ROUTE	STATE	DISTRICT	SHEET NO.
67	MO	10	217
JOB NO. JOP0931		CONTRACT ID.	
PROJECT NO.		COUNTY WAYNE	
DATE

Subject Re: Fw: VE J0P0931 - box culvert modifications

SUBJECT: District 10 - Construction
Value Engineering Proposal
Job No. JOP0931
Route 67
Wayne County

CULVERT SECTIONS
SHEET 20 OF 41

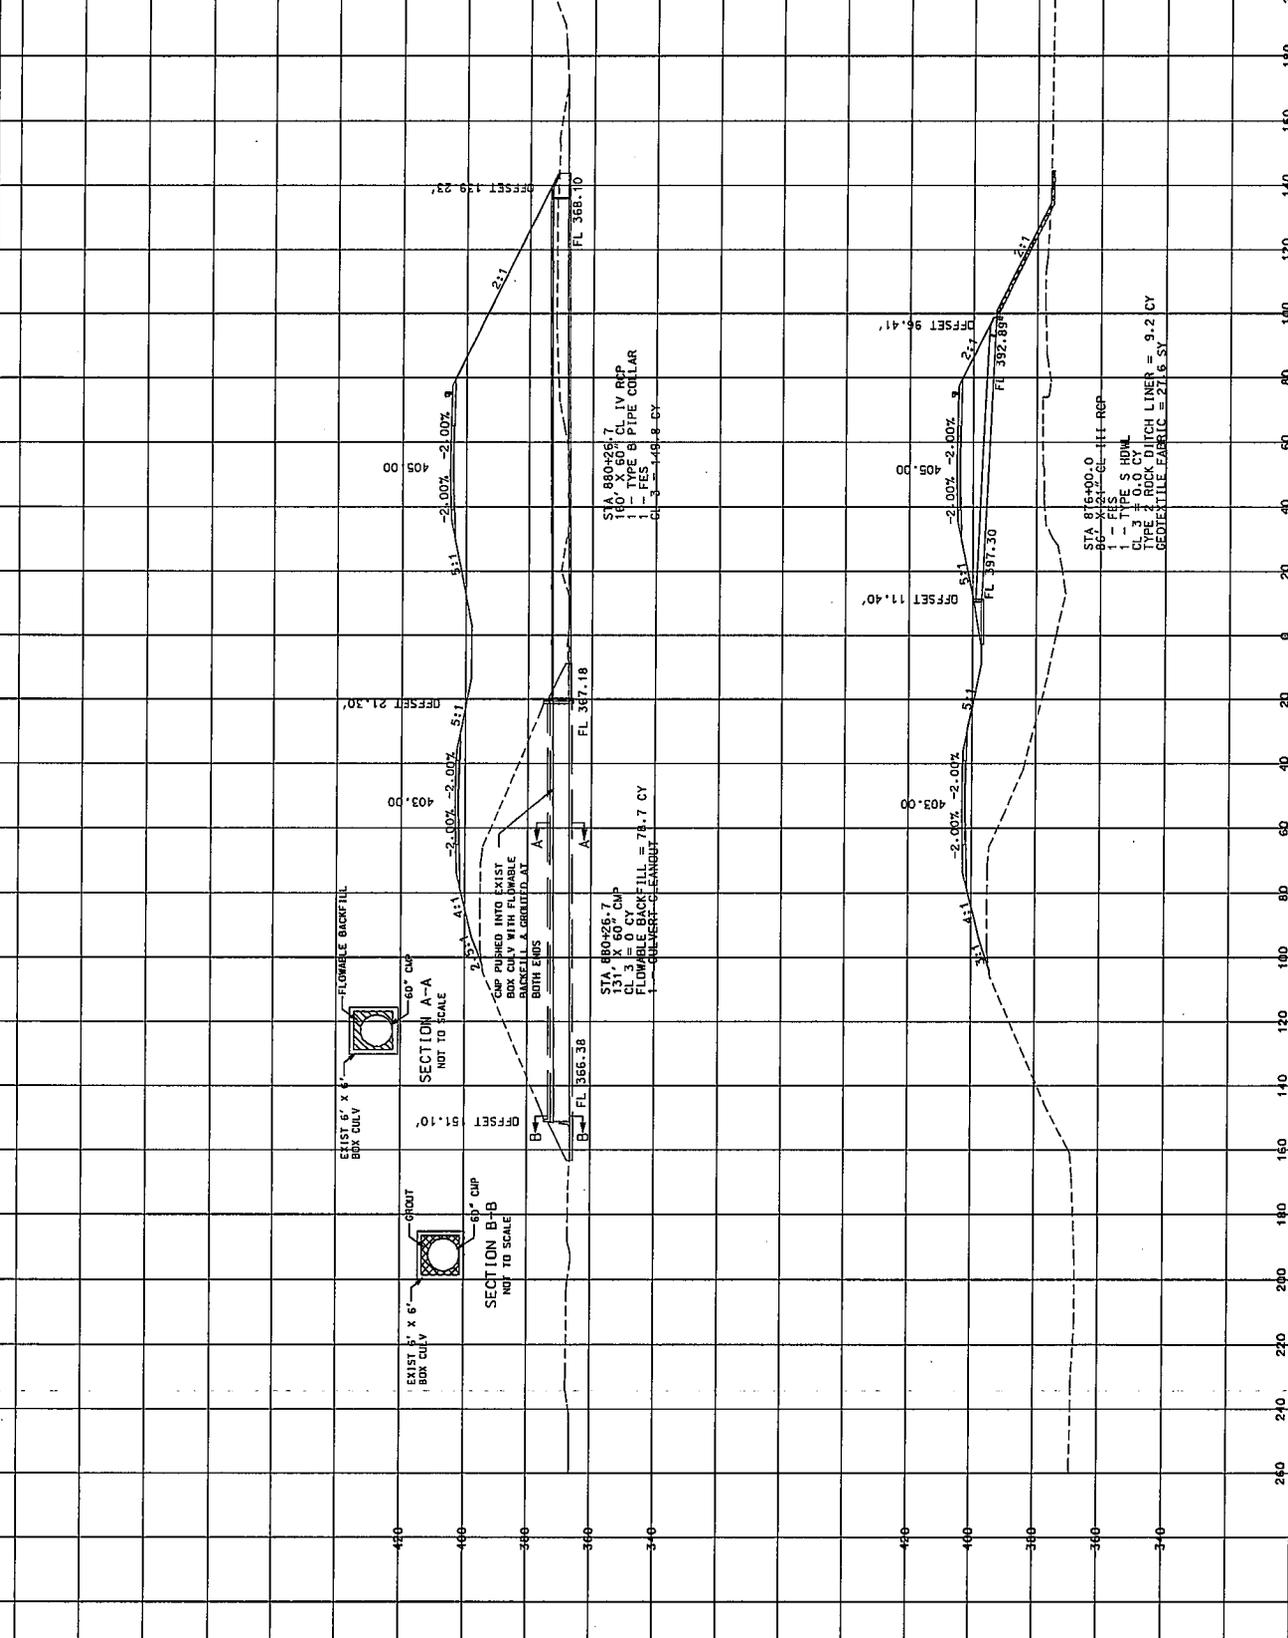
Comments: I RECOMMEND THIS PROPOSAL BE REJECTED. THE EXISTING CULVERTS @ STA 880+26.7 & 736+02.5 ARE STRUCTURALLY DEFICIENT TO HANDLE THE ADDITIONAL FILL PLACED ON THEM. THE CMP INSERTS AND FLOWABLE FILL IDENTIFIED WERE CHOSEN AS THE MOST COST EFFECTIVE SOLUTION. OTHER SOLUTIONS PROPOSED DURING DESIGN PHASES WERE LIGHTWEIGHT FILL, BUT PROVED TO BE MUCH MORE COSTLY.

I agree with the rejecting the proposal. These boxes were not designed for the additional fill that is being placed on them. They were checked for the new fill height and they were found to be overstressed. The additional fill would make them structurally unsound.

I feel that 88026 needs to stay the way we designed it for the very reason you mentioned: the inlet. I wouldn't be opposed to sealing the grout at the inlet end with a concrete cap and paying for it as an additional collar.

I agree w/ rejecting the VECP as per the reasoning in attached note- but, I counter w/ this- can we underrun the length of pipe- just put it where the culvert has added fill- not the entire culvert? For instance- @ sta 736+02 use 70', not 177', @ sta 880+26, use 85', not 131', @ this location the grouted end would be the inlet side, we may need to do something extra here.
